Intended for  
**UPC Renewables Australia Pty Ltd**

# **STUBBO SOLAR FARM** **RESPONSE TO** **SUBMISSIONS REPORT**

Project name **Stubbo Solar Farm**  
Project no. **318001132**  
Recipient **UPC Renewables Australia Pty Ltd**  
Document type **Response to Submissions report**  
Version **V2**  
Date **01/06/2021**  
Prepared by **Taylor Hancock / Belinda Sinclair / Jon Williamson**  
Checked by **Jon Williamson**  
Approved by **Jon Williamson**  
Description **Response to Submissions Report for the Stubbo Solar Farm project.**

**Figure 1: Land Use (DPIE 2017) and reference polygons for aerial imagery below**

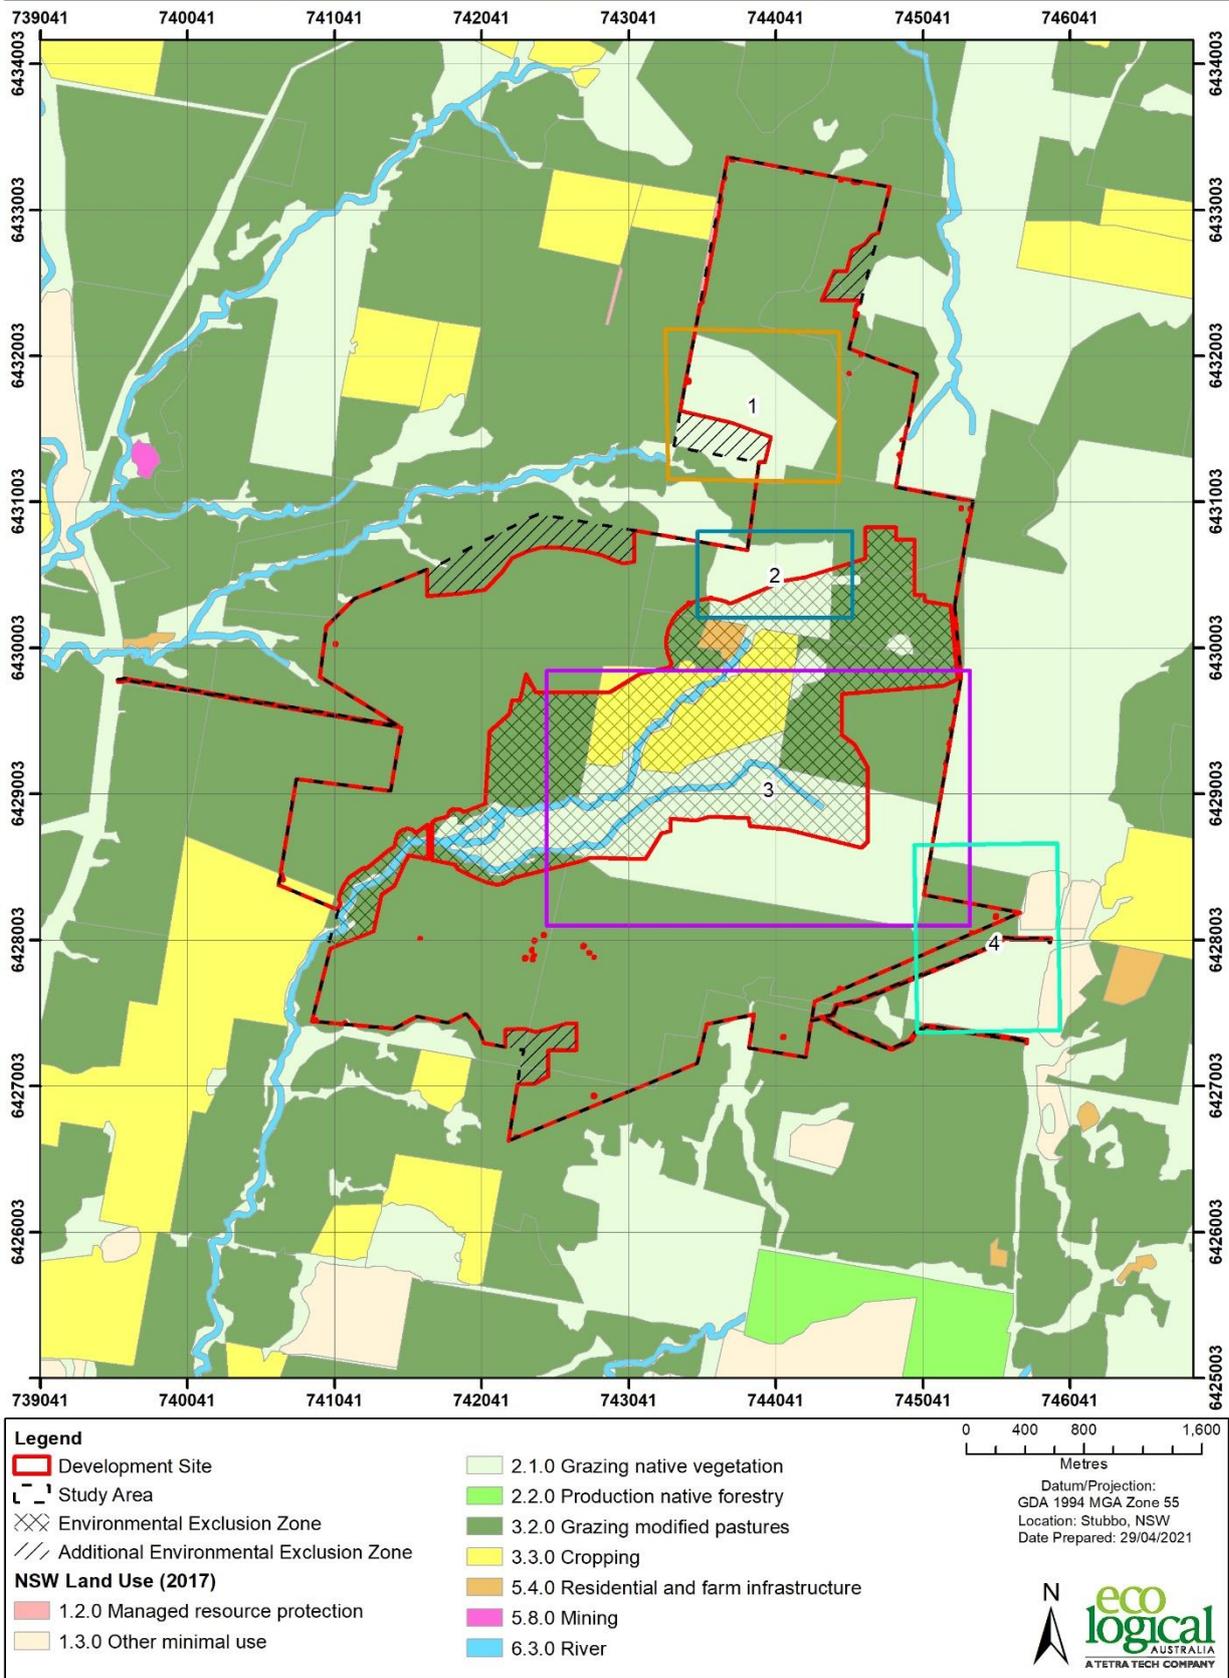
*2.1 In order to exclude *Euphrasia arguta* from the candidate list based on the absence or degradation of habitat constraints not listed in the TBDC the assessor must provide adequate justification in the BDAR. As a minimum, the justification must include;*

1. Modified pasture in the NSW Land Use Mapping (DPIE, 2017)
  - The majority of the development footprint is identified as “Grazing modified pastures” in the NSW Land Use Mapping (Figure 1). A small proportion of the development footprint is mapped as “Grazing native pastures”; however, in these areas there is evidence of ploughing in current and historical aerial imagery and these areas were observed to be in the same condition as the remainder of the site.

Figure 1 presents the NSW Land Use Mapping (DPIE 2017) and reference frames for the corresponding screenshots in Plates 1-4 with evidence of pasture improvements.
